August 29, 2013

**Subject: Turners Falls Hydroelectric Project, FERC Project No. 1889
Northfield Mountain Pumped Storage Project, FERC Project No. 2485
Comments on Revised Study Plan**

Figure 1: Example of “plan view” spatial graphic that may be created within the “HABTAE” program of the PHABSIM for Windows software.

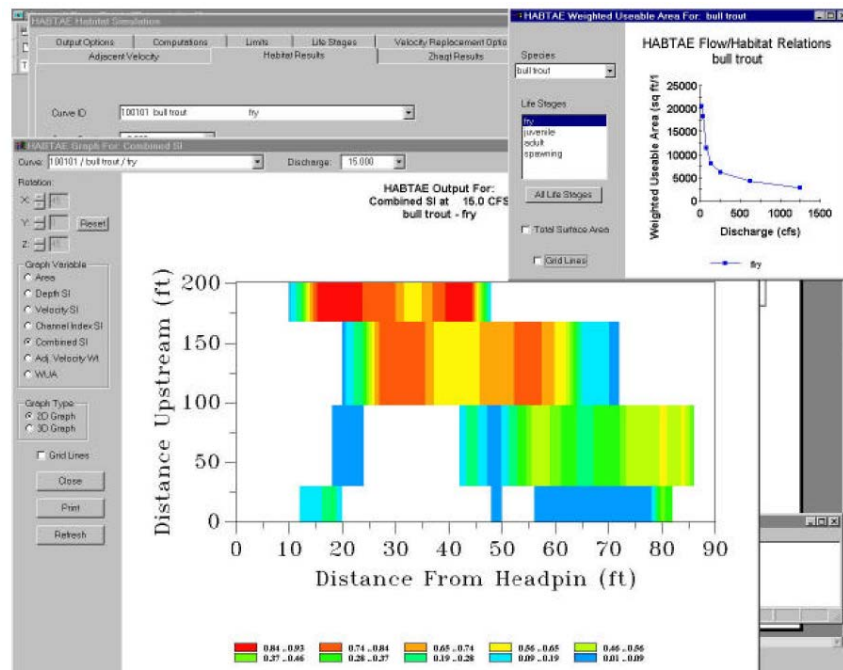
In the comments that we provided regarding FirstLight's PSP, we recommended the inclusion of spatial graphics that depict weighted usable area across cells and over a range of flow values for all sites for which 1D analysis is conducted. In addition, we provided an example graphic (Figure 1) that can be produced using the software PHABSIM for Windows v. 1.5.1, which is the

software that FirstLight proposes to use for this study (identified on page 3-105 of the RSP). On page 3-111, FirstLight states, “Spatial plan views of habitat suitability for a subset of species/life stages and flows will be displayed graphically. These will be identified in consultation with stakeholders to narrow the number of maps to be developed.” This statement appears to meet the recommendation we included in our comments to FirstLight, as mentioned above. However, in the “Matrix of Comments and Responses” of the RSP, FirstLight’s Response to our comment is recorded as, “...we have not seen any currently available technology that will spatially present dual-flow results from a one-dimensional model...” (p. 3-435), which is similar to statements made on pages 3-109 and 3-110. While we are uncertain if PHABSIM can be used to calculate persistent habitat, we are aware of its capability to create spatial plots that depict model results across cells, with distance from the headpin on the x-axis, distance upstream on the y-axis, and the value (e.g., of the combined suitability index) of each cell depicted by a color indicating the range in which the value falls (Figure 1). We assume that these are the “spatial plan views” mentioned on page 3-111; however, to avoid miscommunication, we include further details concerning these plots below. While PHABSIM may not directly calculate habitat persistence, providing multiple plots across a range of discharges would allow for a crude but adequate assessment of habitat persistence at a site. Also, it may be possible to evaluate habitat persistence by creating an additional plot that displays minimum values across a range of flows. We are uncertain if this can be accomplished with PHABSIM, or if use of additional software (e.g., Microsoft Excel, Adobe Illustrator) would be necessary to create such a plot.

In the User Manual for the PHABSIM for Windows software (Waddle 2012; available: http://www.fort.usgs.gov/Products/Publications/pub_abstract.asp?PubId=15000), examples of spatially-depicted results may be found on pages 170 and 171 (for 3-dimensional charts, note the selected button under “Graph Type” on the left hand side of the screen capture), page 273 (for a standard 2-dimensional chart; the chart shown in Figure 1), and pages 274 and 275 (for charts using results that include the value of adjacent cells). All of these charts can be created using the “HABTAE” program of the PHABSIM software. In the PHABSIM user manual, the 2-dimensional charts are also referred to as “plan view plots.” Instructions on creating these plots can be found on page 112 of the PHABSIM user manual. In brief, within the /Models/HABTAE window, under the “Habitat Results” tab, “The Graph button in this tab displays a plan view plot of the suitability for the study site... A Print button is supplied so color copies of the plots can be produced for inclusion in reports” (p. 112 of the PHABSIM user manual). We recommend the inclusion of these “plan view plots” within the study report. Because creating plots for every species and every life stage under multiple discharge scenarios may be unnecessary and excessive, the decision concerning which plots to include in the study report should be determined in consult with agencies and other stakeholders, as suggested by FirstLight on page 3-111.
